WASH ZONE JSP18-50

Consideration at the request of National Car Wash Solutions for Planning Commission's approval of Preliminary Site Plan and Storm Water Management plan. The subject property is vacant land which is part of Novi Ten Shopping Center. The applicant is proposing to develop a 4,788 square foot auto wash building with related drive-through lane and 13 vacuum stations. Related changes to the existing parking lot are proposed to accommodate the drive-through for the car wash.

PLANNING REVIEW

Re: Wash Zone
JSP 18-50
Revised Plan Date: May 10, 2019

CLIENT: NATIONAL CAR WASH SOLUTIONS
 PROJECT: WASH ZONE EXPRESS
 SHEET: 4 OF 12
 DATE: 06/20/19
 DRAWN BY: JH
 CHECKED BY: JH
 DESIGNED BY: JH

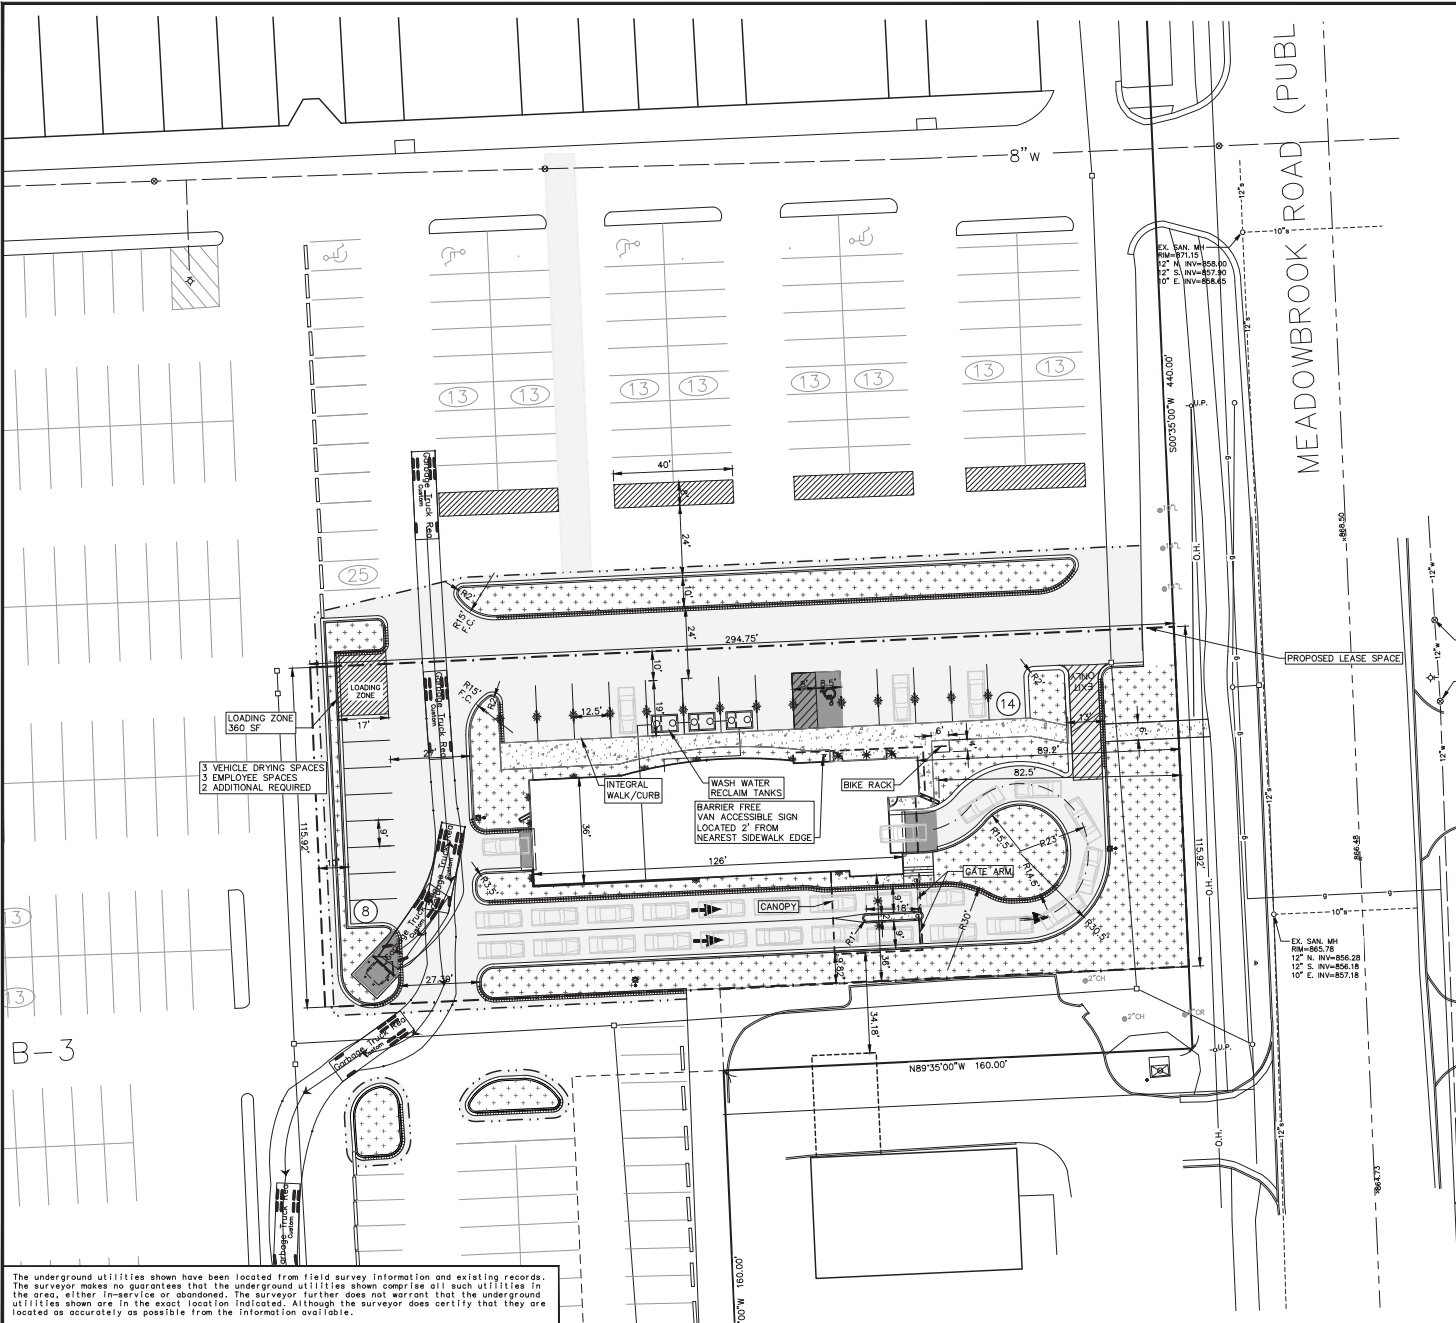
- f. Note 2 on sheet 4 indicates all curbs are 4" high. Curbs adjacent to 19' parking spaces must be 6", as well as curbs on landscape islands, unless the curb is abutting 17' parking spaces, where the curb is to be 4" in height.

2. The signing table provided on sheet 10 should be moved to the site plan on sheet 4 and should include the quantity for each sign.
 - a. The codes listed for the accessible parking signs do not match those in the MMUTCD. Instead of D9-6 and D9-6p, the codes should be R7-8 and R7-8p, respectively.

WASH ZONE EXPRESS
PRELIMINARY SITE PLAN
LANDSCAPE PLAN

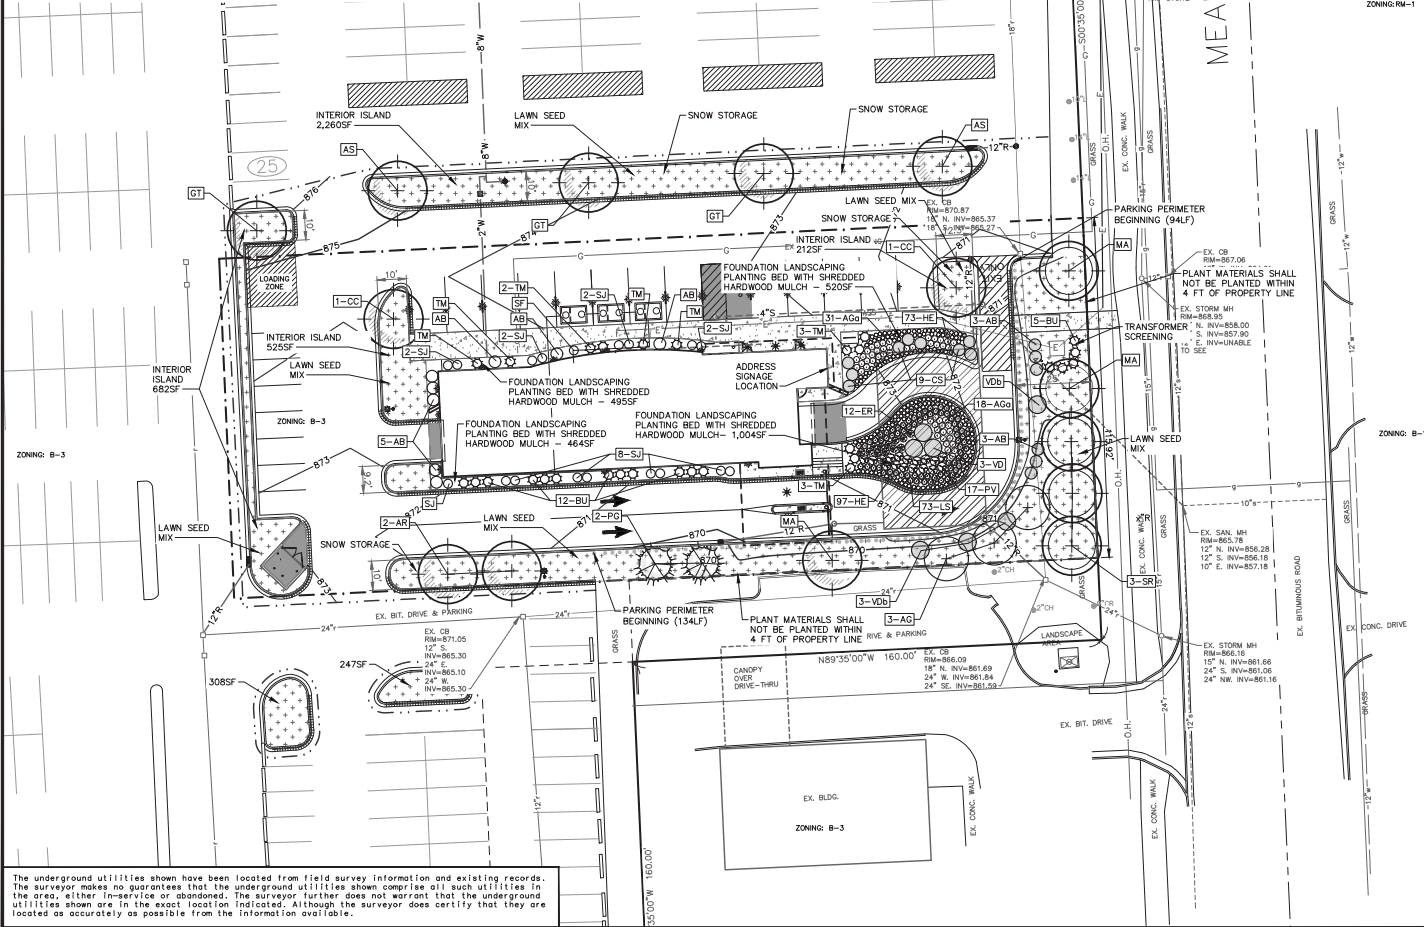
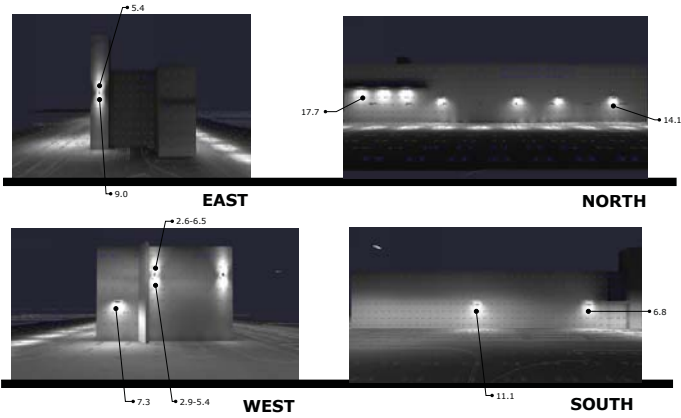
1. Three street trees are located behind the sidewalk. *A waiver to not plant them at all would be supported by staff as there is not room for the required street trees.*
2. The eastern foundation landscaping is not located at the building. *It is supported by staff as the landscaping is just across the sidewalk from the building.*

2. The required canopy and subcanopy trees are provided.
3. Based on the frontage, 4 street trees are required. 3 street trees are planted in the greenbelt. *Due to the lack of room for street trees in the right of way (conflicts with overhead wires, the sidewalk and underground utility lines), a landscape waiver for the 4 street trees would be supported by staff (ie they don't need to be provided).*

1. Based on the vehicular use area, 1,529sf of interior landscape area and 8 canopy trees are required. 3,679sf of area and 8 trees are provided.
2. Based on the perimeter provided, 7 canopy trees are required. 3 canopy trees and 2 evergreens are provided as perimeter trees along the south access drive. 2 greenbelt trees are double-counted as perimeter trees, but they must be moved to within 15 feet of the curb to count as a perimeter tree. Please do so, or add 2 canopy trees within 15 feet of the curb.
3. Please replace the 2 evergreen trees with deciduous canopy trees.

Wash Zone Car Wash
Novi, MI

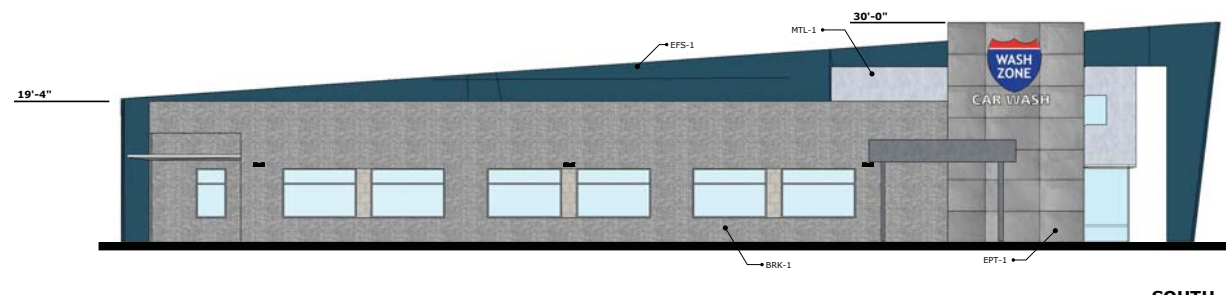
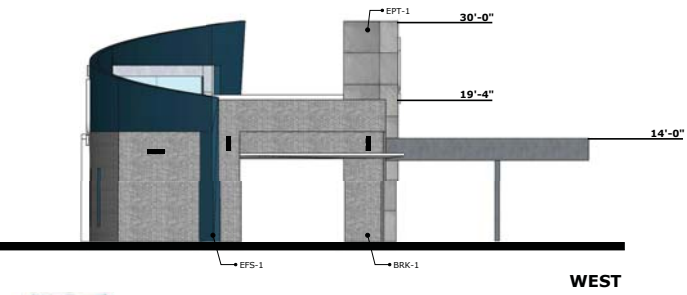
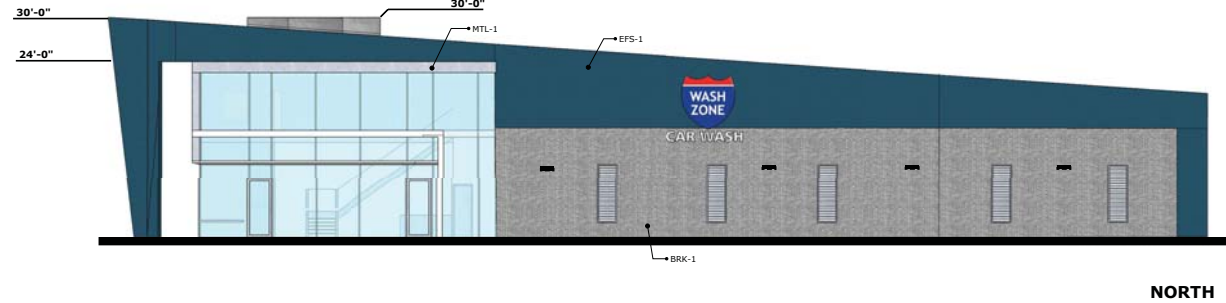
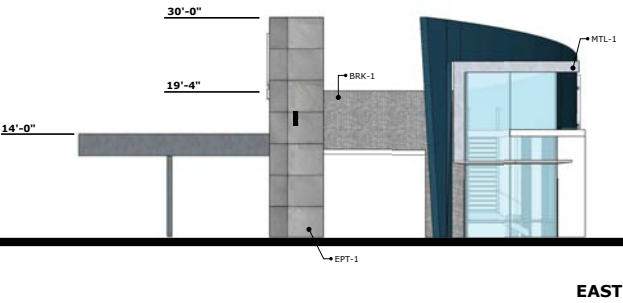
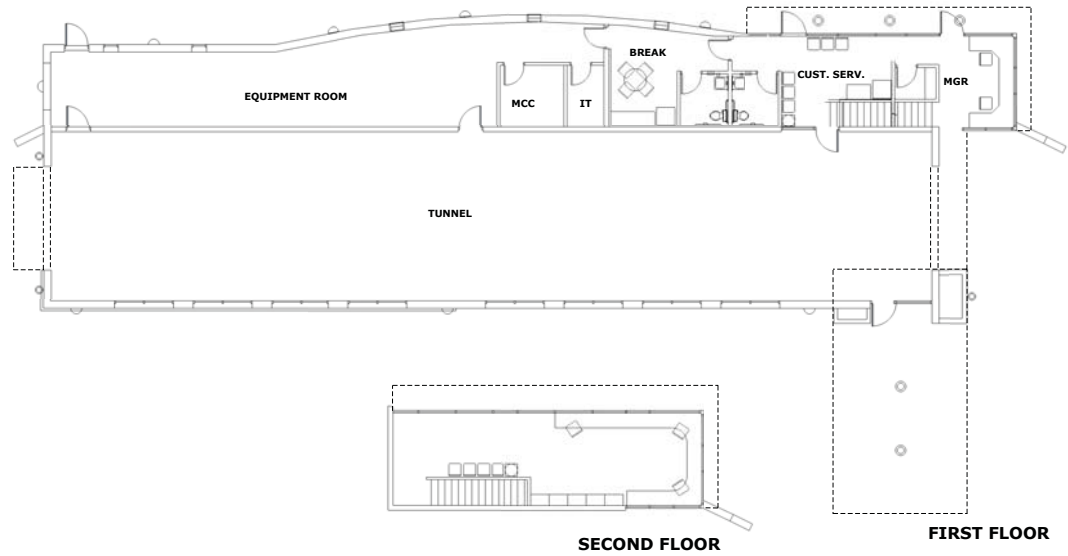
- a. Underage of brick (30% minimum required, 22% proposed);
 - b. Overage of Ceramic tile (25% maximum allowed, 35% proposed);
 - c. Overage of EIFS (25% maximum allowed, 28% proposed);

4. The applicant shall revise the north building elevation to conform to the Façade Ordinance requirements at the time of Final site plan approval;
5. Subject to Zoning Board of Appeals variance from Section 5.3.11.F. for not meeting the minimum centerline radius for drive-thru lane (25' minimum radius required, 23 feet proposed);

Recommendation –We believe that the other deviations are minor in nature and that the overall design would qualify for a Section 9 Waiver if the percentage of EIFS is brought into closer compliance with the Ordinance. For example, this could be accomplished simply by raising the brick height and reducing the EIFS height by approximately 3.5’ on the north façade. It is our recommendation that a Section 9 Waiver be granted for the underage of Brick and the overage of EIFS and Ceramic Tile, contingent on this or other equivalent revision being made at the time of Final Site Plan Approval.

Exhibit 2-3. Minimum Turning Path for Passenger Car (P) Design Vehicle

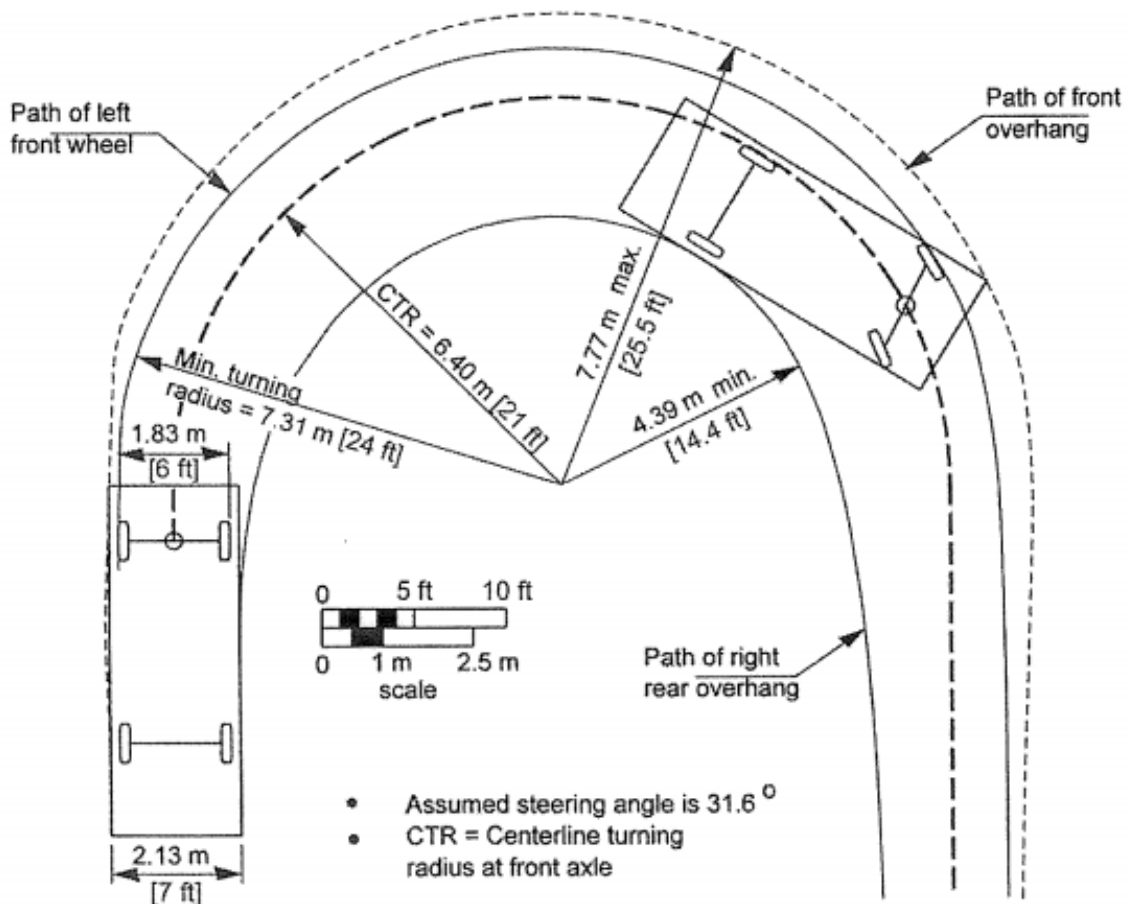
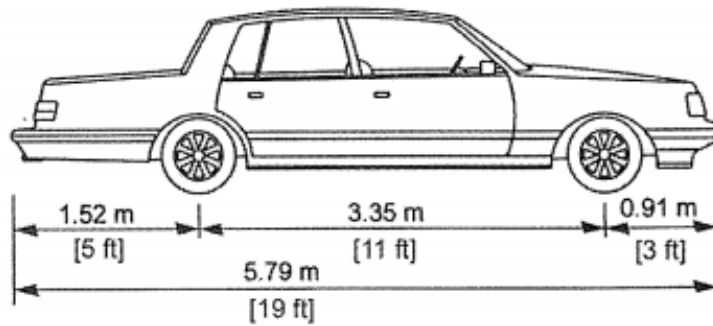
1. The applicant should update the plans to meet the minimum radius requirement. The applicant provided passenger vehicle turning radii exhibits to justify the proposed design but should also include a pickup truck design. If the minimum radius is not met, a variance may be required.
